## Product / Process Change Notification (PCN)

<p><b>PCN #:</b> PCN_PeSMBU_20230703</p> <p><b>Affected Series:</b> WP-SMBU; 7466003R, 7466004R, 7466103R, 7466104R, 7466203R, 7466204R</p> <p><b>PCN Date:</b> April 03, 2023</p> <p><b>Effective Date:</b> July 03, 2023</p>	<p><b>Change Category:</b></p> <p><input type="checkbox"/> Equipment / Location  <input checked="" type="checkbox"/> General Data  <input type="checkbox"/> Material  <input type="checkbox"/> Process  <input type="checkbox"/> Product Design  <input type="checkbox"/> Shipping / Packaging  <input type="checkbox"/> Supplier  <input type="checkbox"/> Software</p>
<p><b>Contact:</b> Product Management</p> <p><b>Phone:</b> +49 (0) 7942 - 945 5001</p> <p><b>Fax:</b> +49 (0) 7942 - 945 5179</p> <p><b>E-Mail:</b> pcn.eican@we-online.com</p>	<p><b>Data Sheet Change:</b></p> <p><input checked="" type="checkbox"/> Yes <input type="checkbox"/> No</p> <p><b>Attachment:</b></p> <p><input type="checkbox"/> Yes <input checked="" type="checkbox"/> No</p>

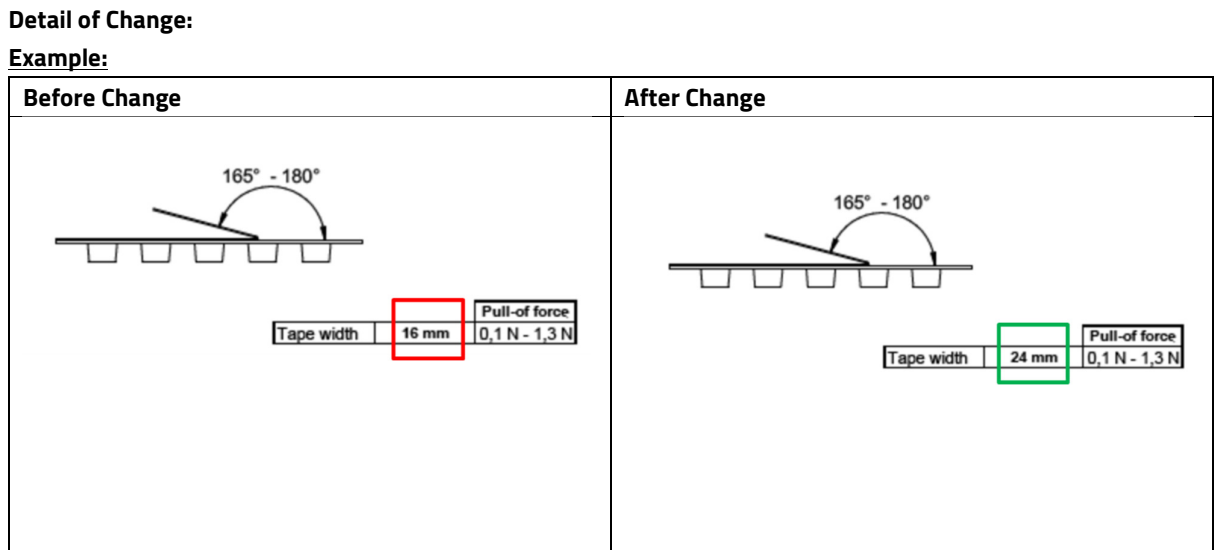
**Description and purpose of change:**  
 Because of a database mismatch, Würth Elektronik has to correct the Packaging Specification of the datasheet (page 2).  
 This is a datasheet correction only. There will be no change in form, fit, function, quality or reliability of the product.

A	B	C	D	N	W1	W2	W3	W3	
tolerance	± 2.0	min.	min.	min.	min.	+ 2	max.	min.	max.	
Tape width	16 mm	330.00	1.50	12.80	20.20	60.00	16.40	22.40	15.90	19.40

W1	W2	W3	W3
	+ 2	max.	min.	max.
16 mm	16,40	22,40	15,90	19,40

A	B	C	D	N	W1	W2	W3	W3	
tolerance	± 2.0	min.	min.	min.	min.	± 2.0	+ 2	max.	min.	max.
Tape width	24mm	330.00	1.50	12.80	20.20	60.00	24.40	30.40	23.90	27.40

W1	W2	W3	W3
	+ 2	max.	min.	max.
24mm	24,40	30,40	23,90	27,40
